Interactive comment on "Optimal Site Selection for Sittinga Solar Park using Multi-Criteria Decision Analysis and Geographical Information Systems (GIS)" *by* Andreas Georgiou and Dimitrios Skarlatos

Andreas Georgiou and Dimitrios Skarlatos

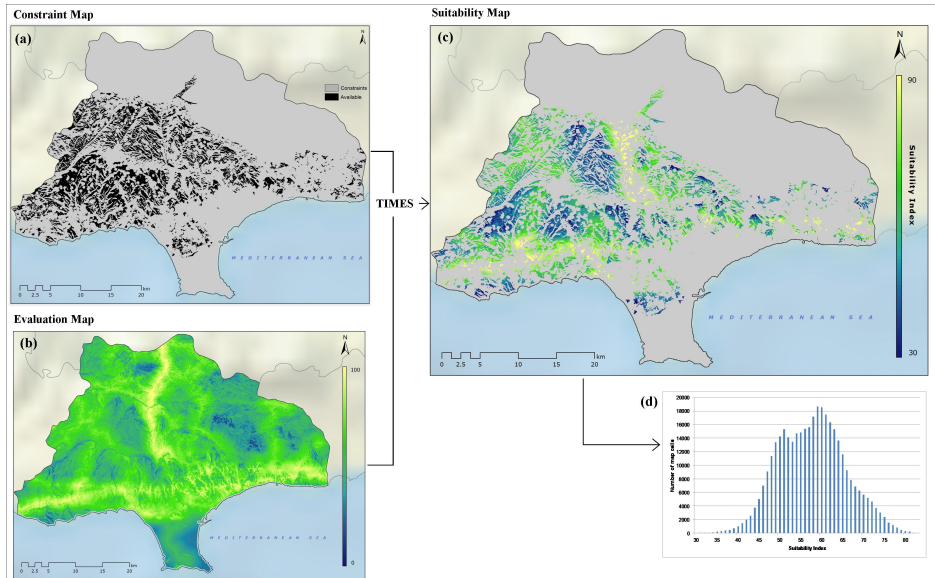
[Comment #5]: Figure 4. Please omit or change it. No info can be derived from it.

[RESPONSE]: We totally removed Figure 4.

Fig. 1. (a) Constraint map; (b) Evaluation map; (c) Final SI map of study area as extracted from the multiplication of the Constraint map with the Evaluation map; (d) Distribution of SI pixels over final map

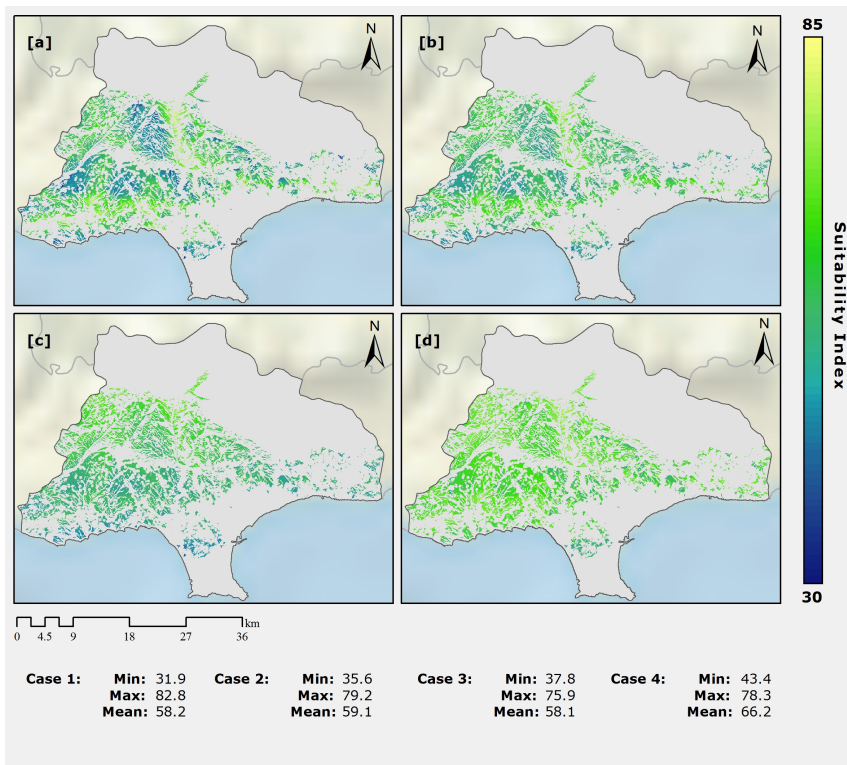
[Comment #2]: Please explain the Figures 2-7 in the text and especially the Figure 7. Results should be explained in detail.

[RESPONSE]: Figures 2 to 7 and the results are briefly explained through the text. We have made some changes in the order of the Figures to address the change in the structure of the paper. In addition, some changes were made in Figures 5 & 6 in order to present better the results and an additional Figure 7 created to present the classified results of the sensitivity analysis (Figure 4 removed as mention in Comment 5 of the MINOR COMMENTS section).
